UNITED STATES PATENT AND TRADEMARK OFFICE

Office Action Summary	Application No. 10/524,957	Applicant(s) PETROSENKO ET AL.	
	Examiner MICHAEL G. BOGART	Art Unit 3761

DETAILED ACTION

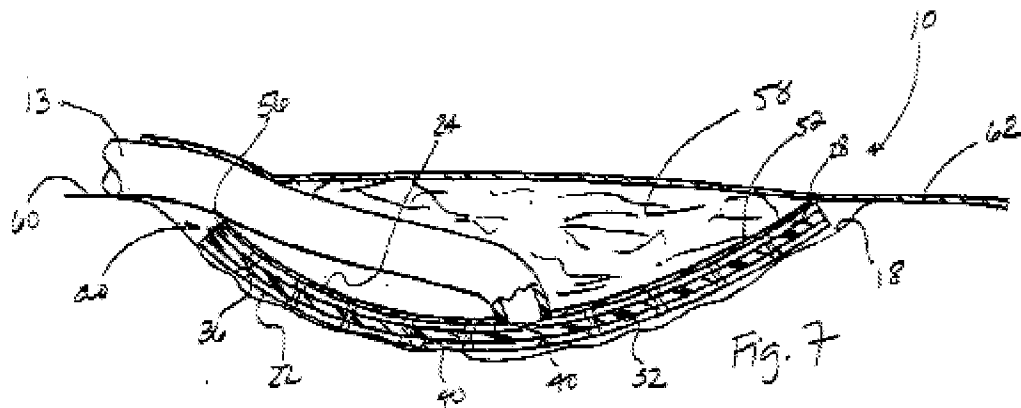
Claims 1-7, 12 and 23 are rejected under 35 U.S.C. § 102(a) as being anticipated by Lockwood *et al.* (US 2002/0065494 A1; hereinafter: “Lockwood”).

Regarding claim 1, Lockwood teaches a vacuum bandage system (10, 12) capable of being used with a wound (16) having a wound surface, the vacuum bandage system (10, 12) comprising:

a wound dressing member (52) made generally of a non-porous material having a plurality of holes and a port (70) in communication with the holes and capable of being coupled to a vacuum source (12), and a wound insert (20) capable of being placed within the wound (16) between the wound surface (18) and the wound dressing member (52), the insert (20) being made of a material which is not porous or foam-like, and

a cover (62) capable of placement over the wound dressing member (52) to seal about the wound (16) and create a sealed environment between the wound (16) and the cover (62) in which negative pressure can be established (§ 0031)(see figures 7 & 15).

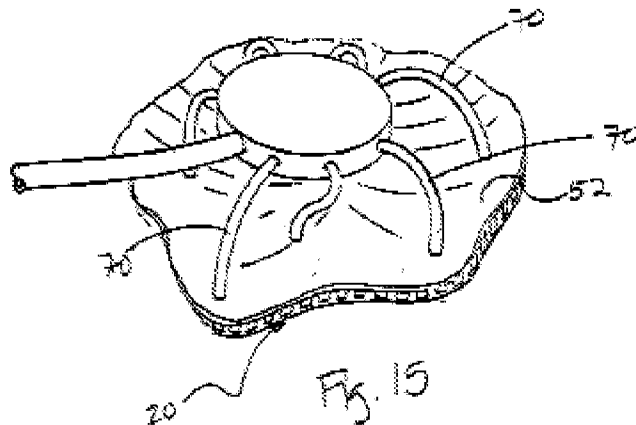
Regarding claim 3, Lockwood teaches that the wound insert (20) includes a plurality of discrete passageways (28, 30, 32, 34, 36) in communication with the vacuum source (110).

Regarding claim 4, Lockwood teaches that the passageways (28, 30, 32, 34, 36, 56) are conduits through the wound insert (20).

Regarding claims 5 and 12, Lockwood teaches an insert (20) that includes a top surface (24), a bottom surface (22), and a side surface, and wherein the conduits (56) form holes or bores in one or more of the side surfaces, and wherein the insert (20) further includes holes (36) in communication with the conduits (56) and forming holes (36) in one or more of the top and bottom surfaces (22, 24)(see Lockwood, fig. 7, supra). Further regarding claim 12, Lockwood teaches a thin flexible member (20) spaced away from the suction tube having bores (36) extending from the top to bottom surfaces (22, 24)(see fig. 15).

Regarding claims 6 and 7, Lockwood teaches channels (28, 30, 32, 34) in each of the top and bottom surfaces (22, 24) and holes (36) between the channels (28, 30, 32, 34).

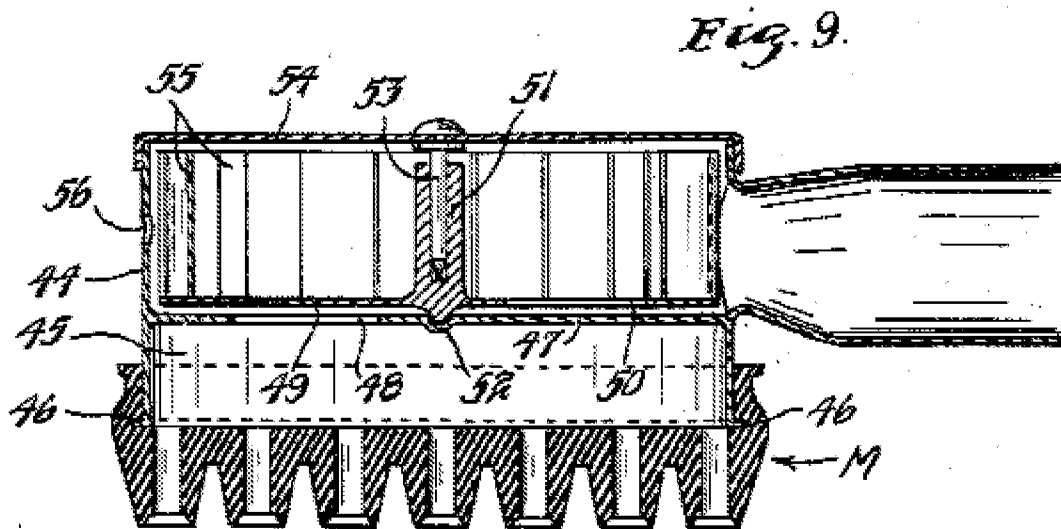
Claims 1, 13, 14, 16, 19, 23-25 and 27-29 are rejected under 35 U.S.C. § 102(b) as being anticipated by La Mere *et al.* (US 2,338,339; hereinafter “La Mere”).

Regarding claim 1, La Mere teaches a vacuum bandage system (11, 12, 13) capable of being used with a wound having a wound surface, the vacuum bandage system (11, 12, 13) comprising:

a wound dressing member (44) made of a generally non-porous material and is capable of contacting a wound having a plurality of holes (48, 50, 56) and a port (15) in communication with the holes (48, 50, 56) and capable of being coupled to a vacuum source (11), and a wound insert (M) capable of being placed within the wound between the wound surface and the wound dressing member (44), the insert (M) being made of a material which is not porous or foam-like (rubber), and

a cover (54) capable of placement over the wound dressing member (44) to seal about the wound and create a sealed environment (45) between the wound and the cover (54) in which negative pressure can be established (see fig. 9, *infra*)(col. 3, line 1).

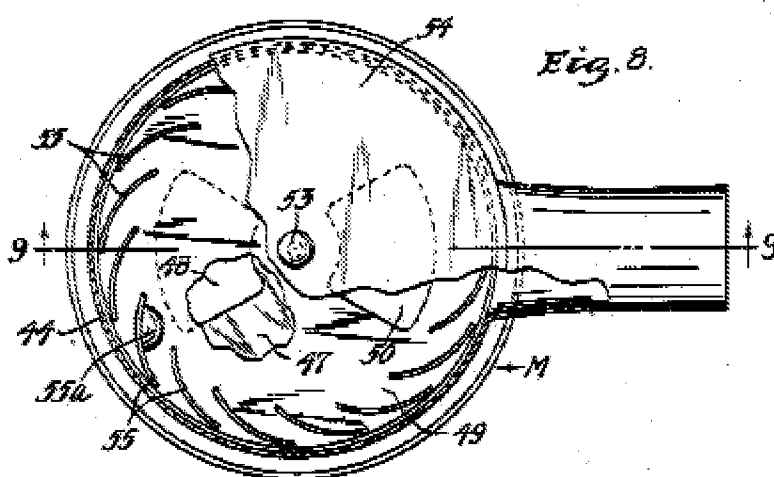
Regarding claim 13, La Mere discloses that the insert body (M) is cylindrical or rod-shaped (see fig. 8, *infra*).

Regarding claim 16, La Mere discloses discrete passageways (24).
